| <b>From:</b> | Digby Wells Environmental         | <b>Proj #:</b> | AFT7855   |
| <b>RE:</b>   | <b>ESIA Groundwater Responses</b> |                |           |

This memorandum provides feedback on groundwater related queries that ECC, the consultants appointed by the client to compile the ESIA for AfriTin.

**Figure 1: Waste Rock Dump Locations and Sample Locations**

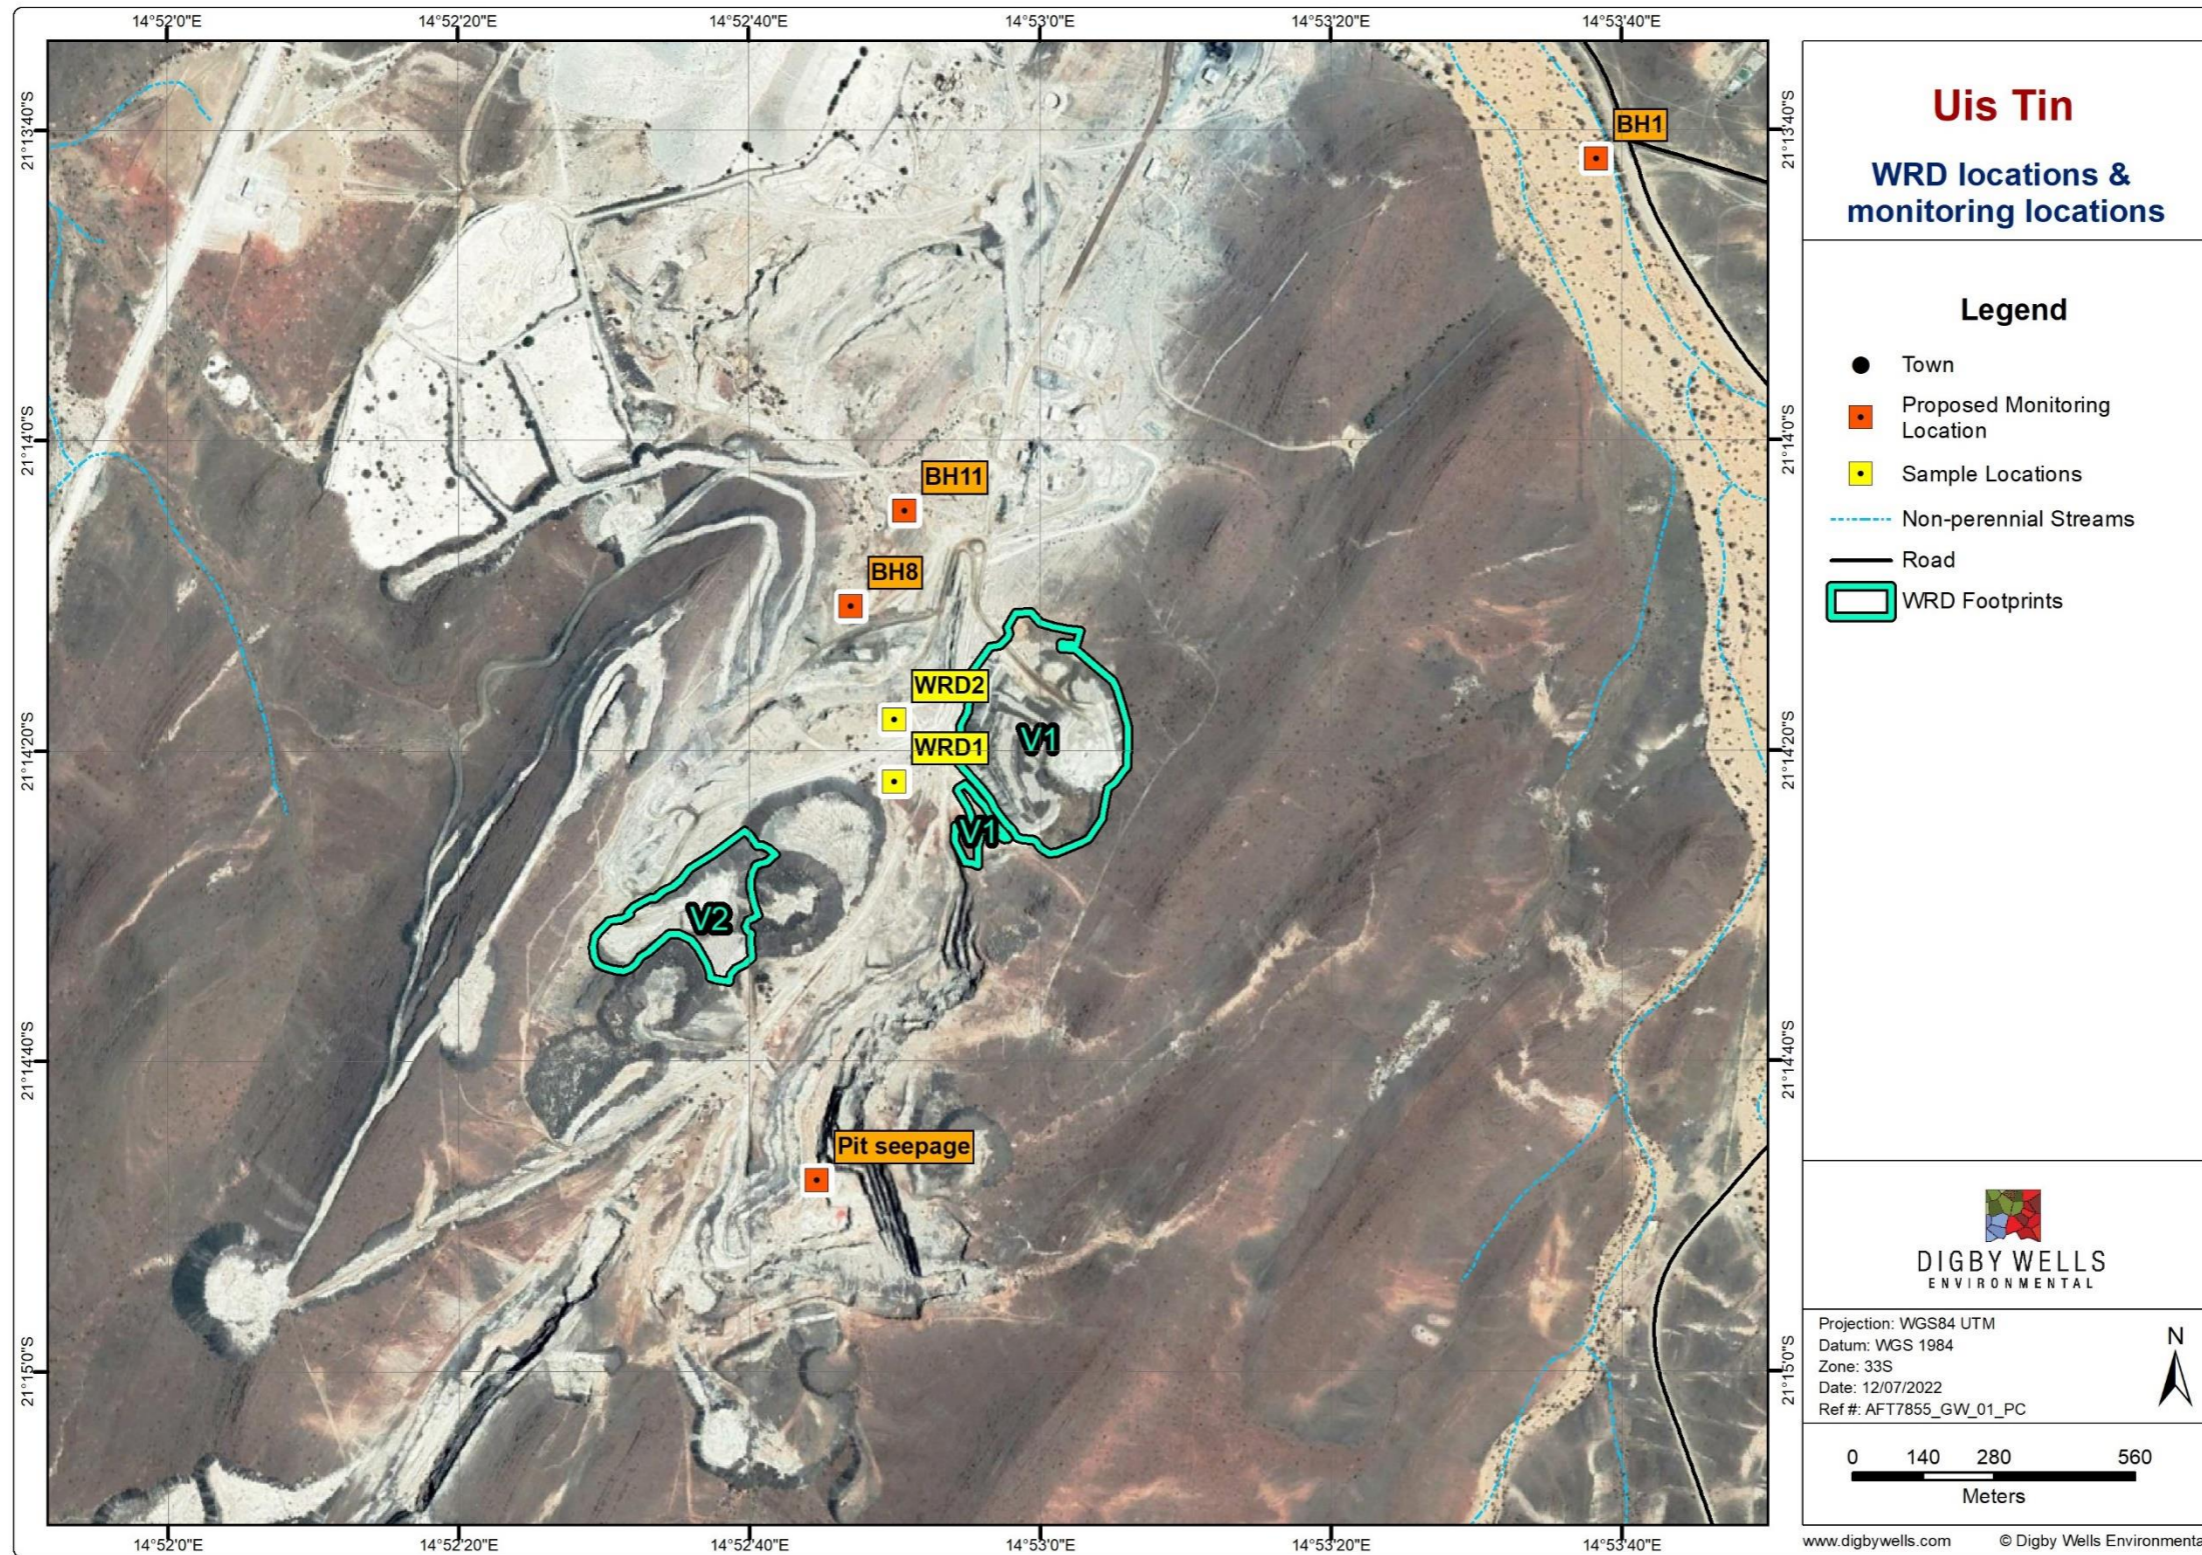
## **2. Develop a contaminant plume model for the site. The flow model should show flow rates and contaminants of concern around key mining infrastructure and into the groundwater regime**

To establish the quality of in-situ water infiltrated through the current waste material, water samples were collected from the toe of both waste rock dumps after the heavy rainfall events in February 2022. The location of the V1 and V2 WRD and the collected samples are shown in Figure 1. The water quality results were compared against the IFC effluent discharge limits (2007) and are summarized in Table 2. The results indicate that the water samples are compliant with regards to these limits.

The V1 and V2 WRDs are located on the perimeter of the V1V2 open pit (Figure 1). Should a significant rainfall event occur which would potentially generate seepage, the seepage will be drawn towards the V1V2 open pit which would act as a groundwater sink, given the high evaporation rates of the area. This will assist in managing any potential contamination plumes from the V1 and V2 WRD facilities. Water supply boreholes BH8 and BH11 are located downgradient of the V1 and V2 WRD and the abstraction from these boreholes will draw groundwater to these locations, where not captured by the V1V2 open pit. These two boreholes must also be included into the monitoring network for the V1 and V2 WRD (Table 3). The WRD1 and WRD2 collected points are included in the monitoring plan for the V1 and V2 WRDs, however should any additional runoff / seepage points be identified during storm events, these must be sampled as well.

**Figure 2: pH Trend**

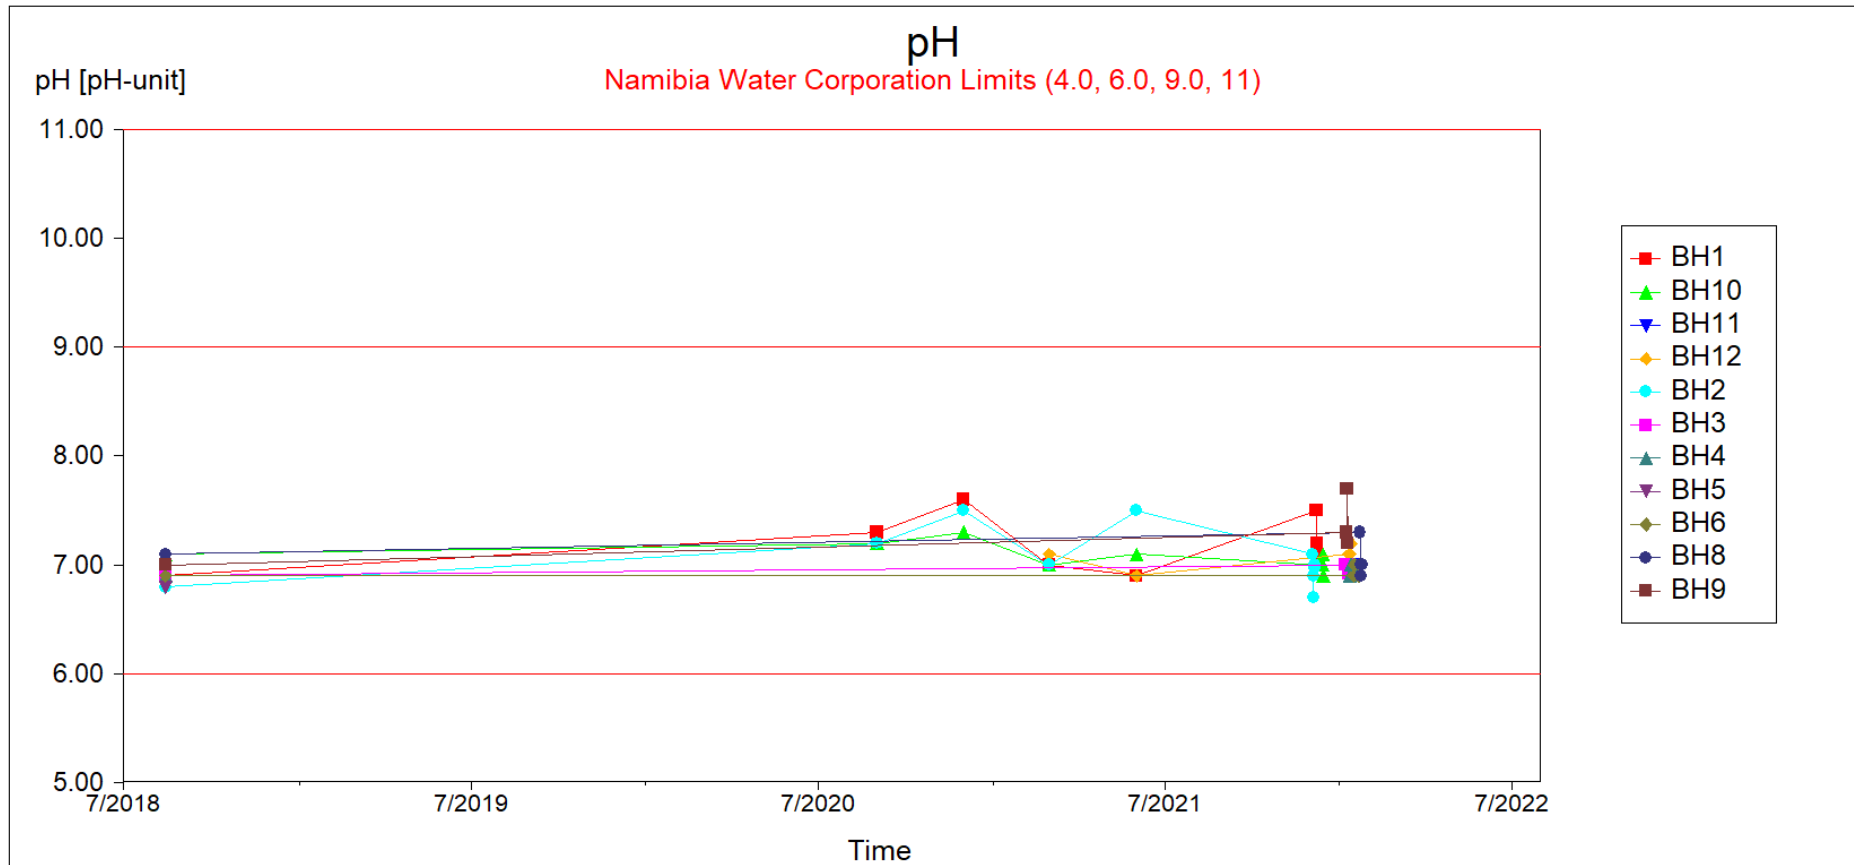
## **5. Review and update the groundwater status report prepared for Uis Tin Mine in 2019 based on the results from monthly monitoring results between 2019 and 2021 (if required)**

pH, electrical conductivity and total dissolved solids were used to describe the general condition of the groundwater. The trends for pH (Figure 2) and electrical conductivity and total dissolved solids (Figure 3) indicate that the results for the water supply boreholes are of a similar range to the boreholes tested in 2018.
